## Product Change Notification / SYST-26RDCU841

ERRATA - PIC18(L)F26/45/46K40 Family Silicon Errata and Data Sheet Clarification

## PIC18(L)F26/45/46K40 Family Silicon Errata and Data Sheet Clarification

Figure 1. 28-pin SPDIP, SSOP, SOIC

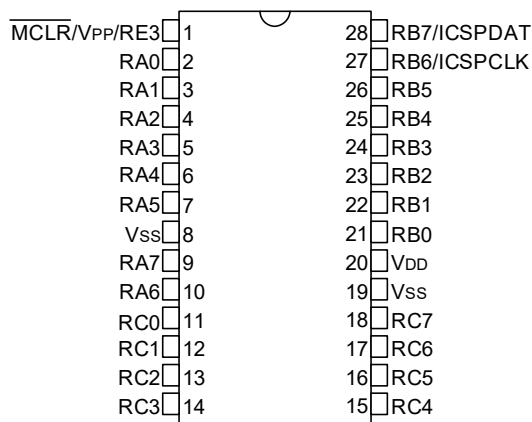
##### 3.2.1 28-pin SPDIP/SSOP/SOIC Pin Diagram

The correct marking for pin 26 on the 28-pin SPDIP/SSOP/SOIC package is **RB5**.

Figure 3. 40-pin PDIP

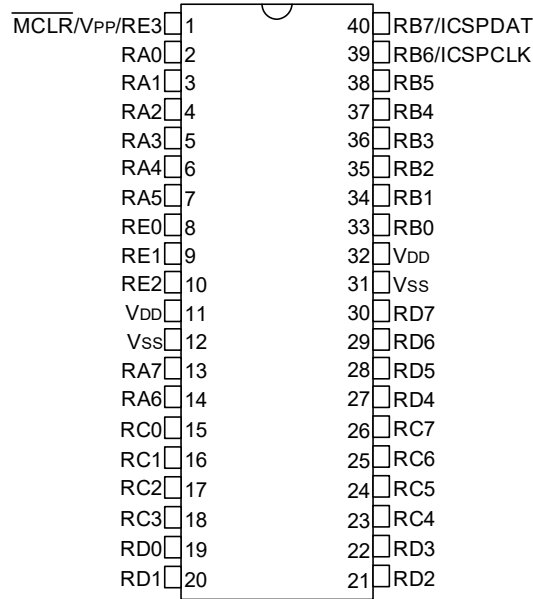
##### 3.2.2 40-pin PDIP Pin Diagram

The correct marking for pin 38 on the 40-pin SPDIP package is **RB5**.

**Figure 38-10: ADC Conversion Timing (ADC Clock  $F_{OSC}$ -Based)**

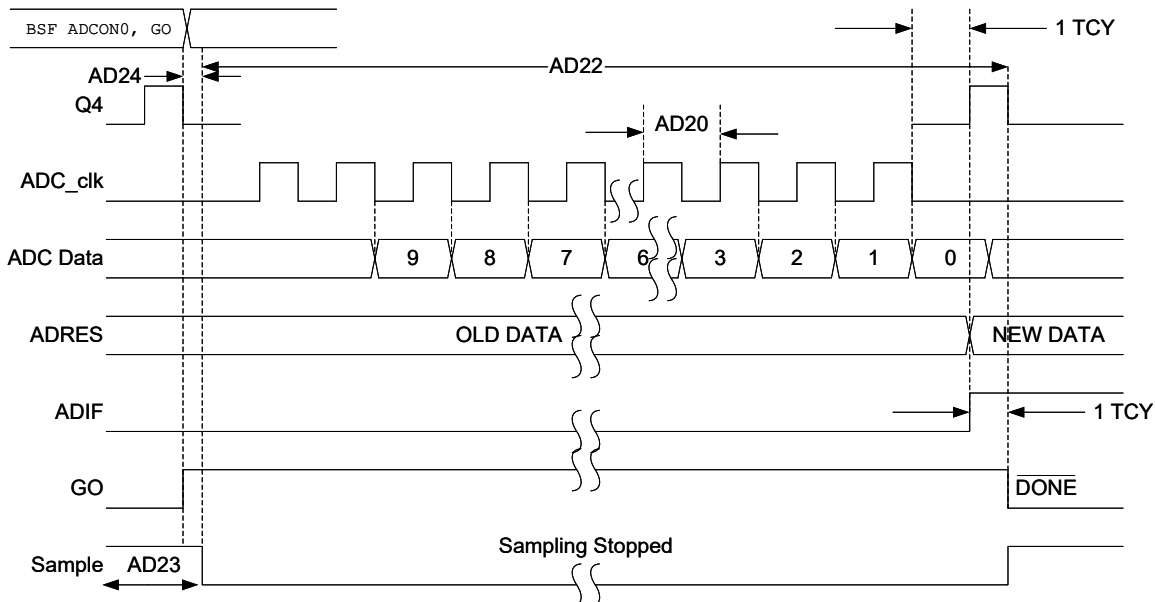
#### 3.3.2 ADC Conversion Timing Diagram

Refer to the images below for corrections of Figure 38-10 and Figure 38-11. Previously, the parameter numbers were incorrect.
